Re: 21014 Western Valley, Katy, Texas

On December 2, 2021, Harris Engineering Real Estate Inspections, Inc. performed a limited inspection at the above referenced address. The sole purpose of the inspection was to evaluate the recent repair work of siding, soffit, and fascia work that had been recently performed.

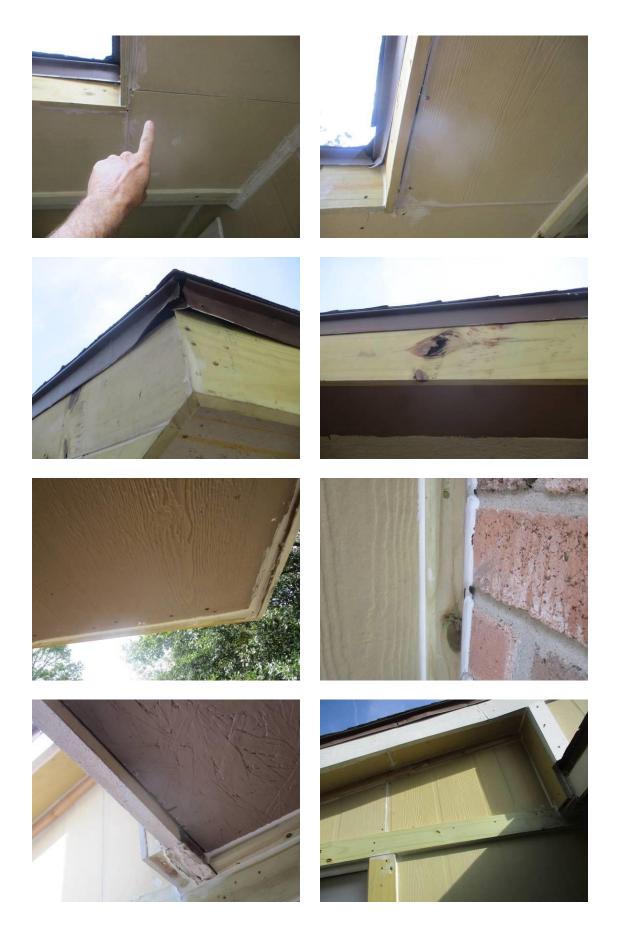
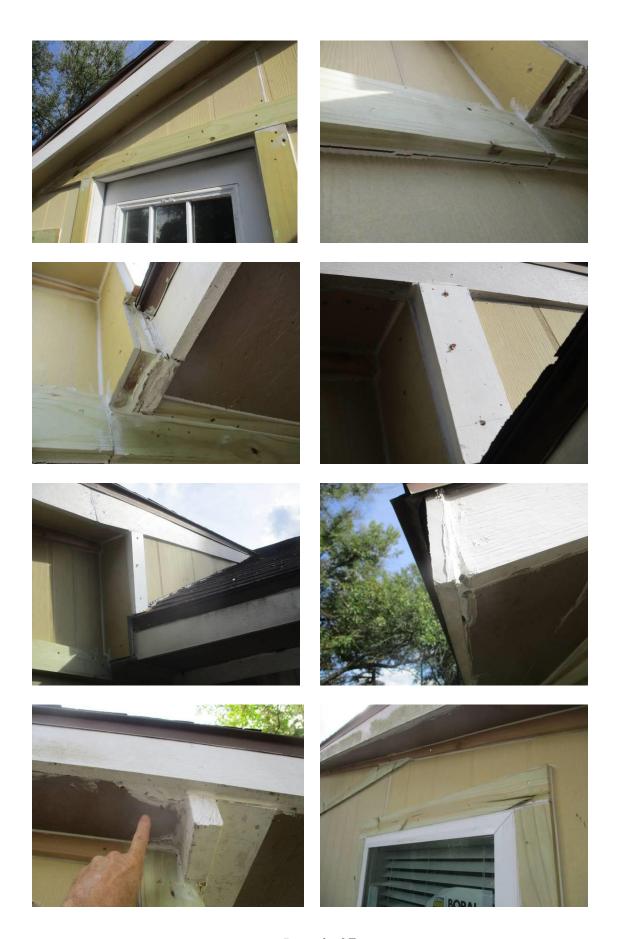
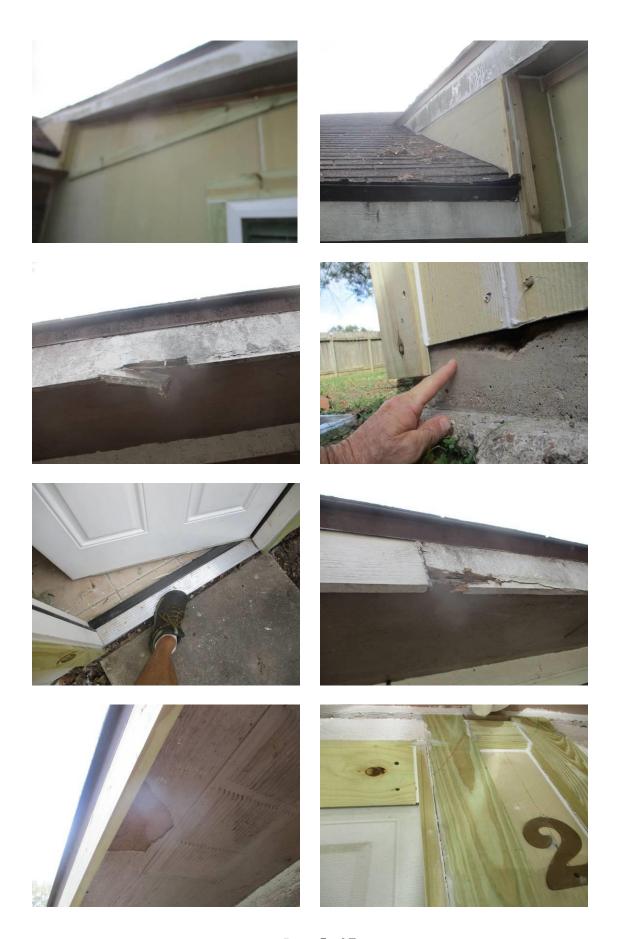
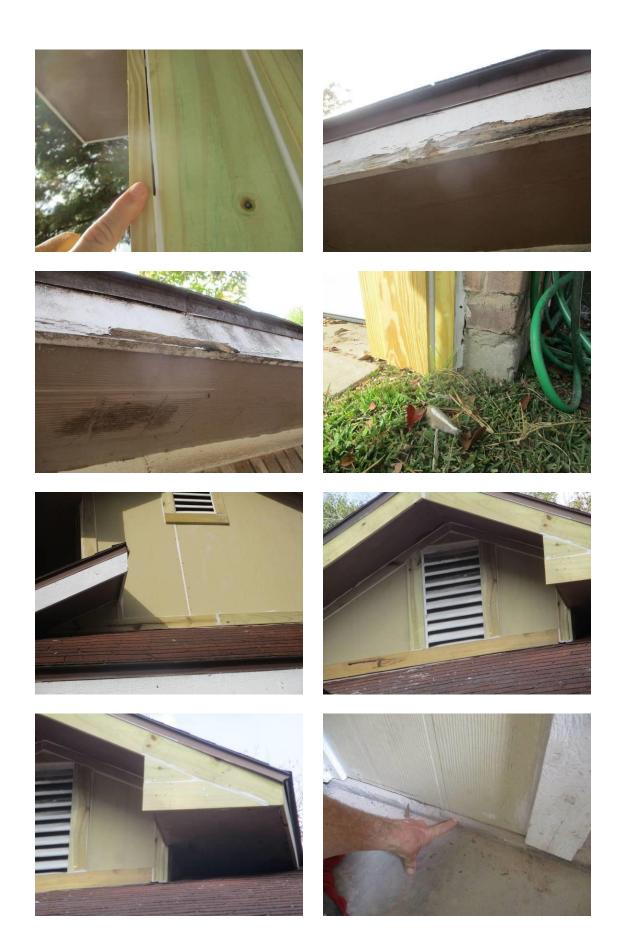
The inspection revealed generally poor workmanship of the recent repairs. The following is a list of generally poor workmanship that was observed: some areas of rotten wood not replaced, poor and missing caulking, lack of flashings at horizontal details, some damaged and missing flashings, areas of loose and deteriorated soffit, inadequate clearance to shingles at siding detail, poor construction joints, siding not projecting over edge of foundation surface, nail heads not flush with surface of siding, some overdriven fasteners, poor details of water resistant barrier, Tyvek, lack of tape at Tyvek details, less fasteners than are generally expected at Tyvek details, lack of flashing above windows, lack of tape at Tyvek connection to windows, incomplete coverage of Tyvek, removed soffit vent cover, and areas of inadequate clearance to grade level at siding and wood trim.

The following photographs document the generally poor workmanship:
